From: tgregsto@blm.gov
Sent: Sunday, July 31, 2011 7:57 PM
To: Cliff P. Brunson
Cc: Dusty Wilson; James Amos; Jennifer Gilkey; Ken Swinney; Terry Gregston; Bratcher, Mike, EMNRD
Subject: Re: FW: Oxy-Jones Canyon 4 Fed. #5: soil sampling question
Attachments: Jones Canyon 4 Federal 5-040610 spill map.jpg

Reference: OXY * Jones Canyon 4 Fed 005 * 30-015-30933 * G-4-22s-24e * DOR-4/6/11 * 2RP-762

From: Cliff P. Brunson [<mailto:cbrunson@bbcinternational.com>]
Sent: Wednesday, July 13, 2011 5:04 PM
To: Bratcher, Mike, EMNRD
Cc: Kelton Beaird; Rick Kerby; Ken Swinney; Jennifer Gilkey
Subject: Oxy-Jones Canyon 4 Fed. #5

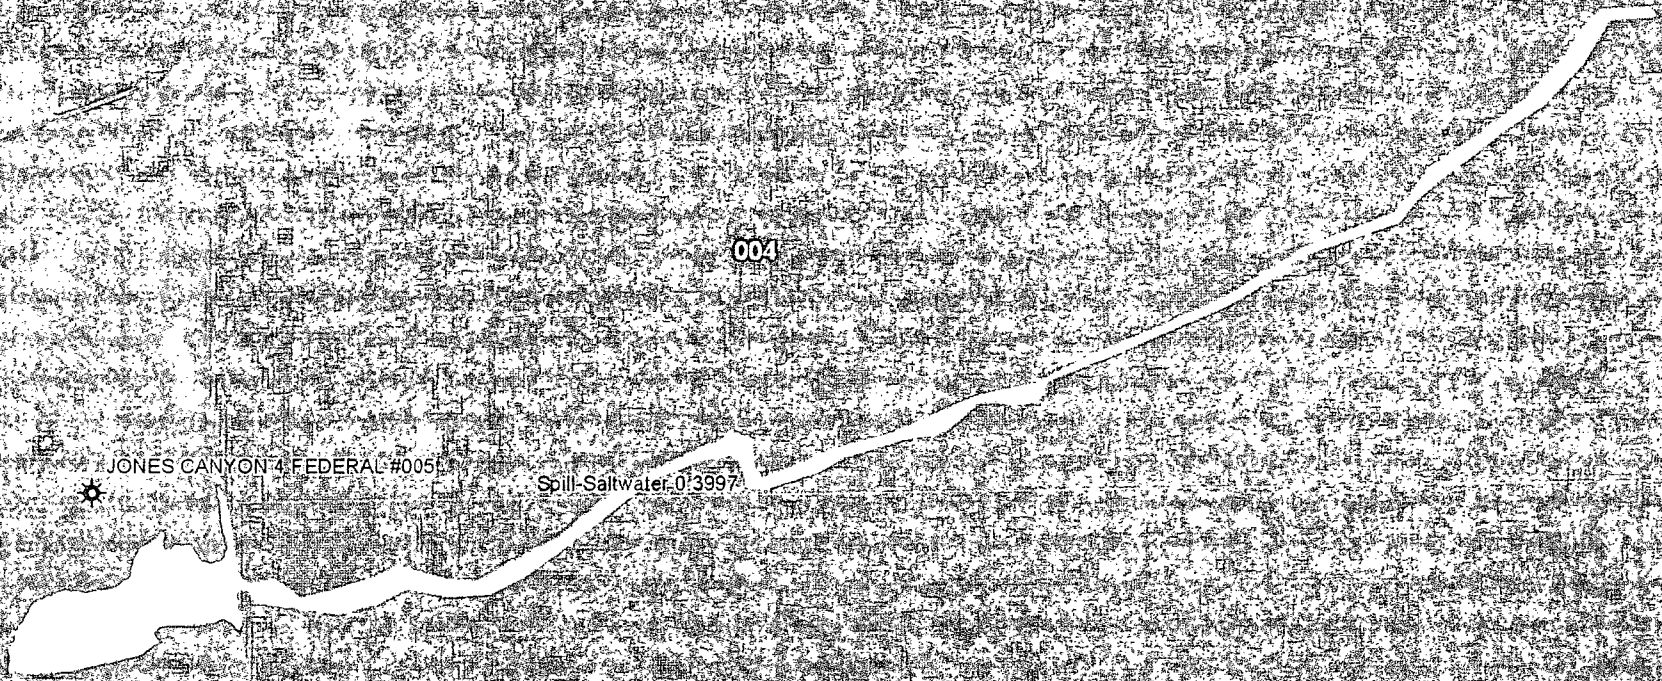
In reviewing your soil sample analysis, there was only one sample taken in the pasture, sample point #7. I did not find any analysis at sample point 7 for the surface; there was just a sample at 1 foot depth.

As you can see from the attached spill map, the spill on this location ran over 1,000 feet out into the pasture. Do you have any other sample data from the spill path after it left the pad?

This message is to confirm our discussion yesterday on July 12, 2011 concerning the remediation plan for the above referenced site. Per our discussion and mutual agreement, Oxy will excavate and remove impacted soil at SP-1 to a depth of 2 feet and in the areas of SP-2, SP-3, SP-4, SP-5, SP-6, and SP-7 soil will be excavated to a one foot depth or as practicable.
